South Holland Drainage Board

Our Ref: 20_02429_C

RE: Consent to discharge surface water run-off to a watercourse

Description of works: Discharge of surface water from 9 dwellings accommodated by drainage improvement works

Figure 1: Extract of 'Proposed Private Culvert / Existing Ditch Diversion' drawing number 356.FH.205 Rev D (Studio 11, Nov 2021).

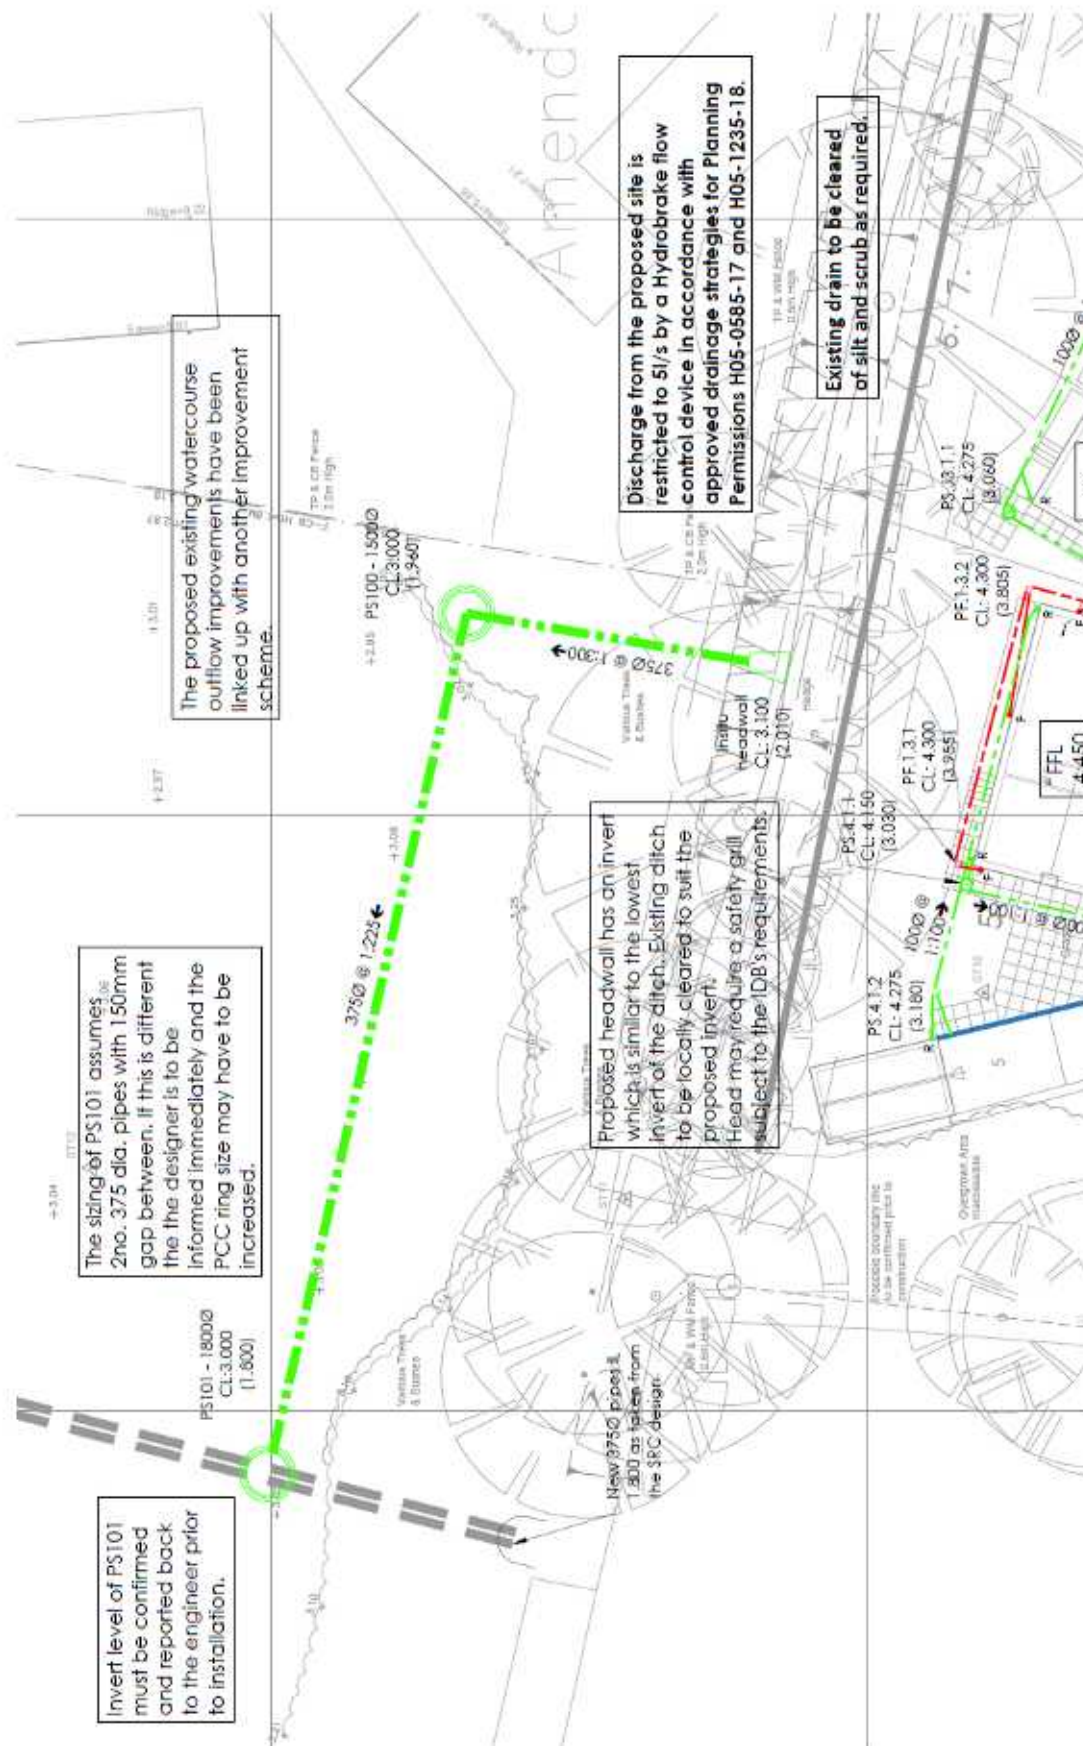
- S2 Discharge rate: The discharge of surface water run-off from this site is to be limited to a maximum rate of 5 litres per second under all circumstances through the use of a flow control orifice located at approximately 539533 , 3250940 in accordance with the submitted plans entitled 'Proposed Private Culvert / Existing Ditch Diversion, 356.FH.205 Rev D' (Studio 11, Nov 2021) and 'Anglian Water Section 104 Plan, 356.FH.200 Rev F' (Studio 11, April 2020) submitted with your application. Any exceedance of the afore-mentioned maximum discharge rate may lead to further action being taken by the Board.

- A culverted connection (375mm internal diameter) between the watercourse specified in S3 (to the North of the development site) and (falling towards) the above culvert as shown in drawing number 356.FH.205 Rev D (Studio 11, Nov 2021).
- Clearance works to the watercourse to the North of the development site to ensure an unobstructed fall in bed level from the outfall specified in S3 (539534 , 325100) to the West towards the inlet to the new culvert connection.
- Clearance and re-profiling and possible widening to the watercourse immediately to the South of the A17 roadway, to ensure the levels are as shown in drawing number 38917/10 Rev D (SRC, August 2019).

Figure 3: Extract of 'Topographical Survey Showing Proposed Drainage & Dyke Improvement Details' drawing number 38917/10 Rev D (SRC, August 2019).

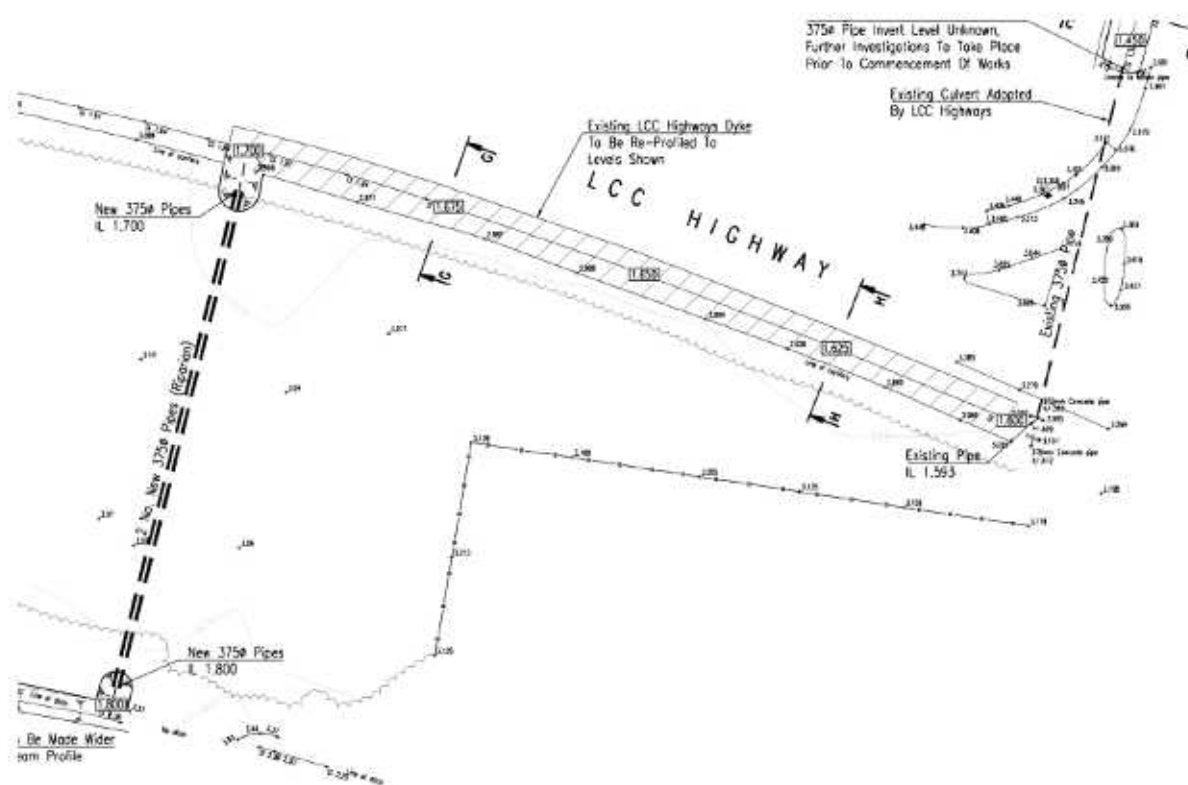
- A new culverted watercourse (2x 375mm internal diameter pipes) between approximately 539474 , 325112 and (falling towards) 539495 , 325182, as shown in drawing number 38917/10 Rev D (SRC, August 2019).

Figure 4: Extract of 'Anglian Water Section 104 Plan' drawing number 356.FH.200 Rev F (Studio 11, April 2020).

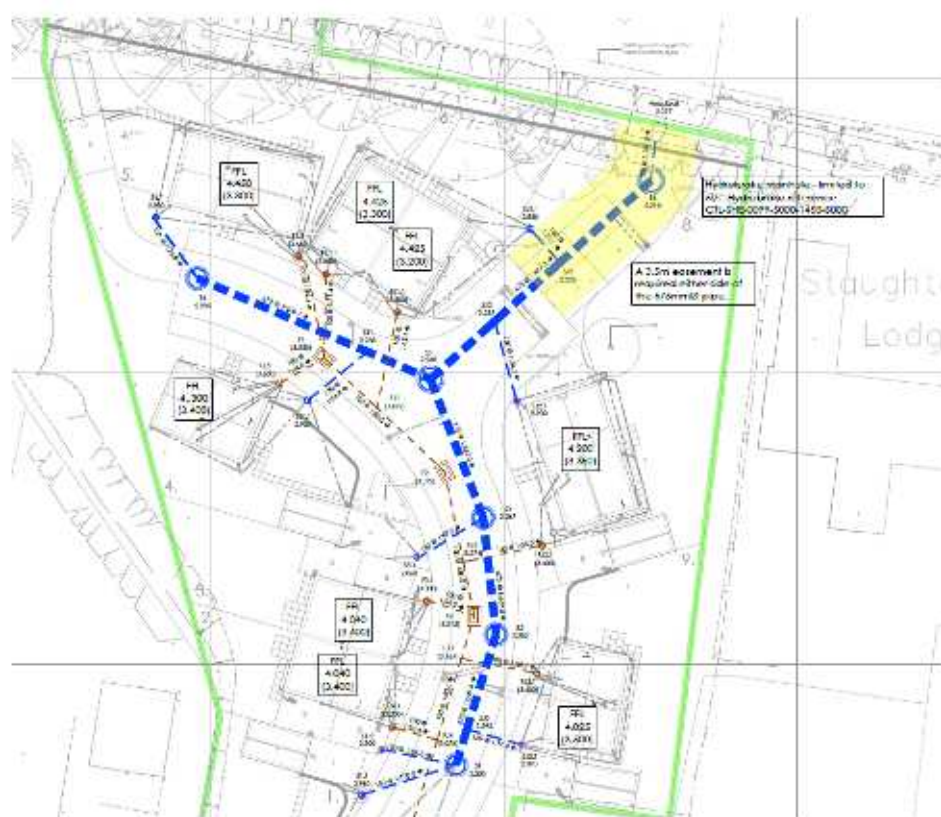
- S1 Attenuation details: Attenuation on site shall be provided through the construction of oversized (675mm internal diameter) pipes built in accordance with the plans entitled 'Anglian Water Section 104 Plan, 356.FH.200 Rev F' (Studio 11, April 2020). These must provide sufficient storage to safely accommodate a 1/30 + climate change event and only minimal external flooding (contained wholly on-site) in the 1/100+climate change events.

- S3 Outfall details: Consent is for the installation of a 150 mm diameter outfall pipe with associated headwall to be constructed in the watercourse to the north of the development site in the approximate location 539534 , 325100 as shown in drawing number 356.FH.200 Rev F' (Studio 11, April 2020) submitted with your application.
